# **SECTION 131 FORM**

FW: PL04.248152-RESPONSE TO THIRD PARTY SUBMISSIONS

Barnadivane Wind Farm, Co. Cork, (An Bord Pleanála Planning Ref. Re: PL04.248152, Cork County Council Planning Ref. 14/557 - Response to Third Party Submissions made to An Board Pleanála

BARNADIVANE 110 KV SUBSTATION, TERELTON, CO. CORK, (AN BORD PLEANALA PLANNING REF. PL04.248152, CORK COUNTY COUNCIL PLANNING REF. 14/557) – RESPONSE TO THIRD PARTY SUBMISSIONS MADE TO AN BORD PLEANÁLA

Figure 3-1: Scenic Routes in Vicinity of the Development.

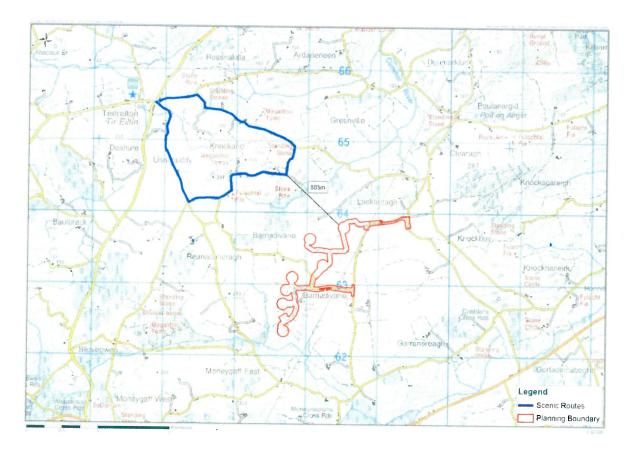
There is a signposted walk, which runs along part of a recognized scenic route along the south-western boundary of the site on the road which goes between T3 and T4 to the east. There are 2 local walking groups using these walks on a regular basis.

No submissions were received from Kilmurray Harriers or other hunting groups in relation to this site being of important use for local hunting activities. Similarly, no submissions were received from local walking groups in relation to their use of the site. Figure 3.1 below indicates that the planning boundary is 885m from the closest scenic route. No recreational trails are in evidence in the vicinity of the site on the Irish Sports Council website <a href="https://www.irishtrails.ie">www.irishtrails.ie</a>. While there are tracks adjacent to the site (grey pecked lines), none of these are marked as waymarked walks in the Ordnance Survey Discovery Series mapping (red pecked lines). It is also important to note the road along the south western boundary is a public road which will not be negatively impacted from the wind farm. Furthermore, wind farms are recognized as sites which can enhance and encourage recreational amenity. In this regard, we note the success of the recreational trail at Mount Lucas Wind Farm Co. Offaly and also the trail being developed in Slieve Bawn Wind Farm in Co. Roscommon. <a href="https://www.sliabhbawnwindfarm.ie">www.sliabhbawnwindfarm.ie</a>.

# APPENDIX 1 – SITE PLAN: H38, H54 & H55 LOCATION IDENTIFICATION

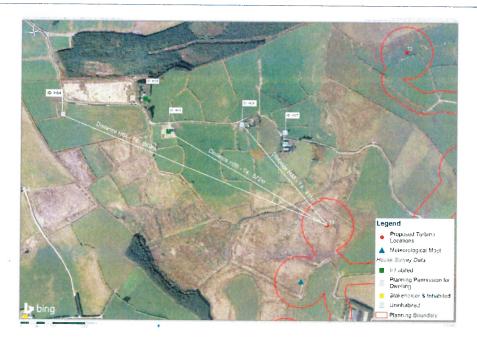
- 3.22 Mr Manning states that both his properties would be subject to cumulative level of noise associated with the Appeal site and the neighbouring Garranereagh Wind Farm. It may be seen from the predictions contained within the EIS and RFI responses that H54 falls outside the predicted 40 dB L<sub>A90</sub> noise contour and as such is not predicted to exceed the 43 dB L<sub>A90</sub> night-time noise limit.

- 3.23 H55 has been predicted to cumulatively exceed the 43 dB L<sub>A90</sub> noise limit by 0.1 dB and 0.2 dB at 8 m.s<sup>-1</sup> and for wind speeds ≥10 m.s<sup>-1</sup>respectivley. This is detailed in Table 8 of Response to Additional RFI dated 9<sup>th</sup> September 2015 from AWNConsulting.

- 3.25 An exceedance of 0.2 dB is a change in level which is not detectable within a laboratory environment for the presentation levels (< 45 dB L<sub>Aeq</sub>) that will, be experienced at the receptor, i.e. this potential exceedance is not noticeable. It should also be considered that the accuracy of a Type I Acoustic Calibrator is ± 0.2 dB, i.e. the appropriate measuring system for determination of compliance is unable to measure that accurately.

- 3.27 The predicted exceedance will therefore be restricted to limited periods of operation during the average year as the property is upwind of the Appeal site in the prevailing wind direction.
- 3.28 Mr Manning also states that his "investment" property is located within 400 metres of Turbine T4 whereas the letter from Mr Buckley (dated 6th October 2017) indicates that Mr Manning's residence is at 572 metres from the nearest turbine. My reading of the submission made by Mr Manning is that his residence is closer to the proposed Appeal site than his "investment" property, i.e. the "investment" property is further than 572 metres from

the nearest proposed wind turbine. It should be noted that Mr Manning has identified H38 within the first figure of his submission as the property at which he resides. However, H38 is considered to be a derelict property for the purpose of the EIS and therefore, following the wind farm planning guidance, has not been considered for noise assessment. It is our understanding that Mr. Manning resides in H55. Appendix 1 details the locations of H38 and H55 for ease of reference.
